## HISTORIC AND DESIGN REVIEW COMMISSION

March 15, 2023

**HDRC CASE NO:** 2022-428  
**ADDRESS:** 1614 E HOUSTON ST  
**LEGAL DESCRIPTION:** NCB 577 BLK 16 LOT 5  
**ZONING:** RM-4, H  
**CITY COUNCIL DIST.:** 2  
**DISTRICT:** Dignowity Hill Historic District  
**APPLICANT:** William Brewer/Done Right Construction DBA  
**OWNER:** GOFORTH DERETHA & PATRICIA SCOTT  
**TYPE OF WORK:** New construction of a 1.5-story, single-family structure  
**APPLICATION RECEIVED:** February 27, 2023  
**60-DAY REVIEW:** Not applicable due to City Council Emergency Orders  
**CASE MANAGER:** Claudia Espinosa

The applicant is requesting conceptual approval to construct a 1.5-story, single-family structure.

P-1

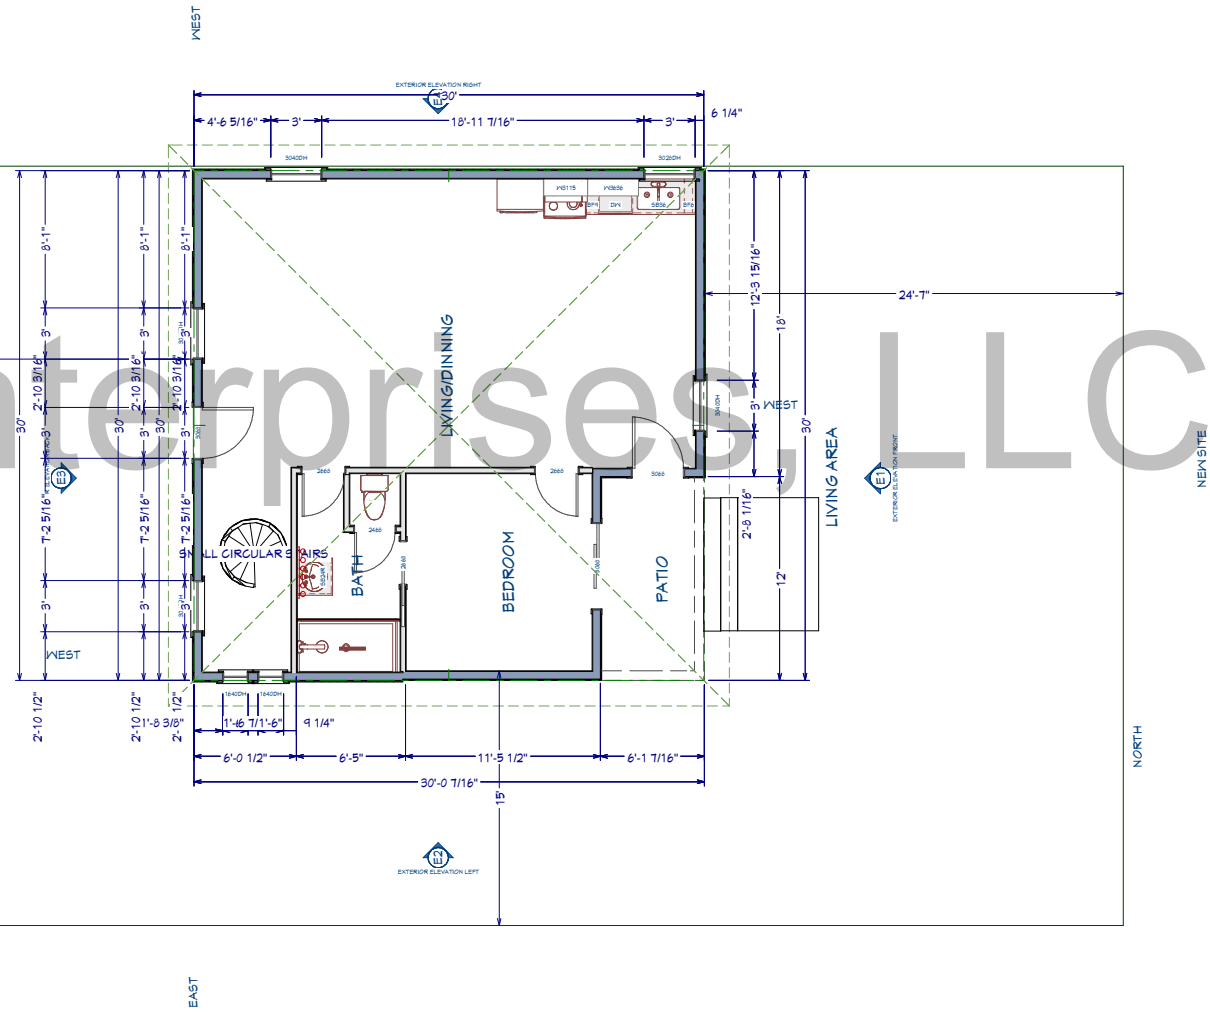
- e. **SETBACKS & ORIENTATION (HOUSTON)** – According to the Guidelines for New Construction, the front facades of new buildings should align with the front facades of adjacent buildings where a consistent setback has been established along the street frontage. Additionally, the orientation of new construction should be consistent with the historic examples found on the block. The applicant has indicated that the structure will be in the same location as the previous structure, which is consistent with the adjacent historic structure located to the east. The applicant has expressed that the adjacent properties feature a setback of 24.7' as shown in the provided site plan. At this time, the applicant has not provided a detailed site plan that shows the location of the neighboring structure. Staff finds that the proposed front setback is generally appropriate, but the applicant should submit a comprehensive site plan showing the location of the proposed new construction on the existing lot and the setbacks of adjacent structures to staff for review prior to issuance of a COA. If approved, the plan will require a variance from the Board of Adjustment for placement on the west property line.

- f. **SCALE & MASS** – The applicant has proposed to construct an approximately 980-square-foot 1.5-story residential structure. According to Guideline 2.A.i for New Construction, new structures should feature a height and massing that is similar to historic structures in the vicinity. In residential districts, the height and scale of new construction should not exceed that of the majority of historic buildings by more than one story. This block within the Dignowity Hill Historic District features 1-story historic structures. Staff finds that the proposed scale and massing of the structure appears generally appropriate, and that the applicant should submit foundation heights to staff for review.

- g. **ROOF (FORM)** – The applicant has proposed a hipped roof form for the proposed new construction. According to Guideline 2.B.i for New Construction, new construction should feature roof forms that are consistent with those predominantly found on the block.. While hip roof forms are commonly found historically, the proposed hip roof features a pitch that is not typical to the district and is not consistent with the original home located on the property.

- h. **LOT COVERAGE** – Guideline 2.D.i for New Construction stipulates that building to lot ratio for new construction should be consistent with adjacent historic buildings. Limit the building footprint for new construction to no more than 50 percent of the total lot area, unless adjacent historic buildings establish a precedent with a greater building to lot ratio. Staff finds the proposal consistent with the Guidelines, per the submitted site plan.

- i. That the applicant submits a comprehensive site plan showing the location of the proposed new construction on the existing lot and the setbacks of adjacent structures to staff for review based on finding e.
- ii. That the applicant proposed a design that more closely matches the original front façade, specifically to include a low, cross gabled roof with inset front porch, side entry, larger window groupings, porch design, and Craftsman details based on findings k and l.
- iii. That any new windows be fully wood and include the specifications listed in finding j.
- iv. That the applicant proposes window sizes, patterns, proportions, and trim and sill detailing that are consistent with the Guidelines and historic precedents in the district as noted in finding g through k.
